Lidl Development, Main Street (R405), Newcastle
Stage 1 Road Safety Audit

Lidl Ireland GmbH

July 2022

Stage 1 Road Safety Audit

Figure 2.2 – Pedestrian Desire Line Which Will Cross the Access

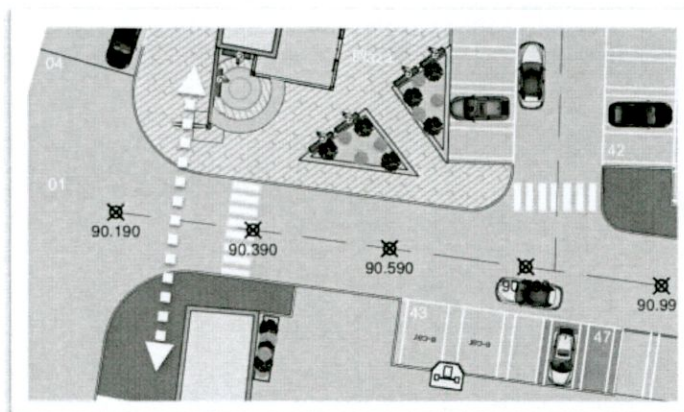
2.2 Problem: Set Back of Pedestrian Crossing

Location: Public Footpath on R405 in Proximity to Site Access

The pedestrian crossing will be set back a significant distance from the pedestrian desire line which crosses the access. This could lead to the pedestrian crossing being ignored, resulting in vulnerable road users coming into conflict with vehicular traffic.

The pedestrian crossing should be aligned on, or closer to the pedestrian desire line on the public footpath which crosses the access.

Figure 2.3 – Area where Errant Parking will Obstruct Service Vehicle Manoeuvring

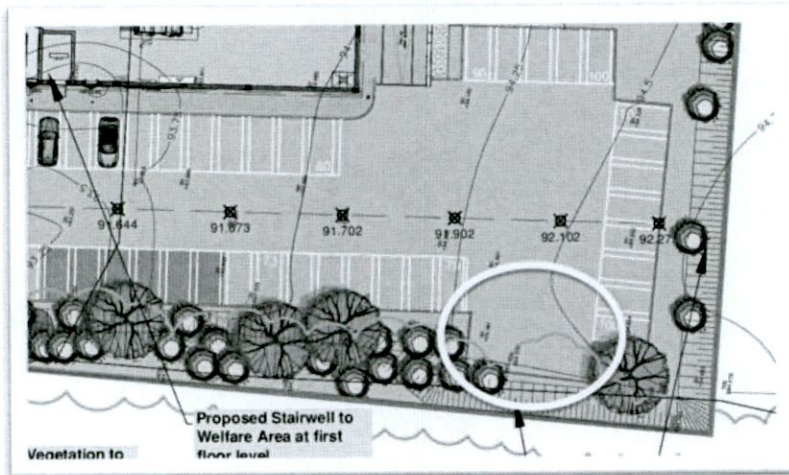
2.3 Problem: Errant Parking in Service Vehicle Turning Area

Location: Southern Section of Carpark and Internal Circulation Road

An area of carpark has been set aside to assist turning and manoeuvring for service vehicles on approach to the dock loader. This area may attract errant parking which could lead to conflicts between service vehicles and store patrons.

Measures to deter errant parking in the area described should be implemented by the Designer.

Figure 2.4 – Kerb Alignment Either Side of Site Access

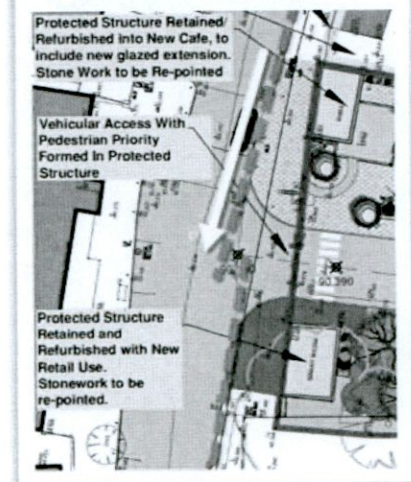
2.4 Problem: Kerb Alignment Mis-Directing Westbound Traffic

Location: R405 in Proximity to Site Access

The re-alignment of the R405's southern kerb line either side of the store access could direct westbound drivers out of their lane and into the opposing traffic lane. This could lead to head-on type collisions.

The kerb alignment should be adjusted locally to provide a smooth and intuitive road alignment and to direct drivers to stay within their lane as they pass the store access.

Figure 2.5 – Space Where Patrons Are Likely to Park

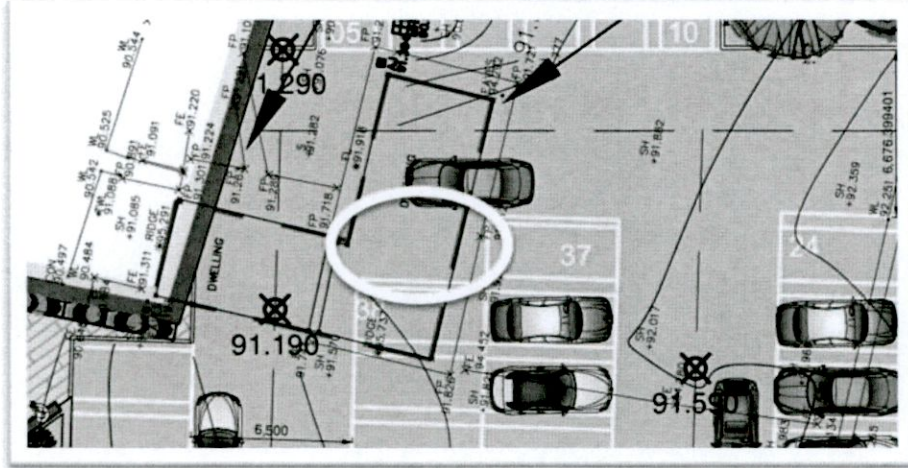
2.5 Problem: Errant Parking Leading to Obstruction in Car Park

Location: Section of Pavement at Corner Between Parking Spaces 37 & 38

Patrons are likely to park in this area, which could lead to driver frustration, delays and vehicle queues impacting upon the operation of the adjacent R405.

A traffic island should be placed at the location described to prevent inconsiderate parking.
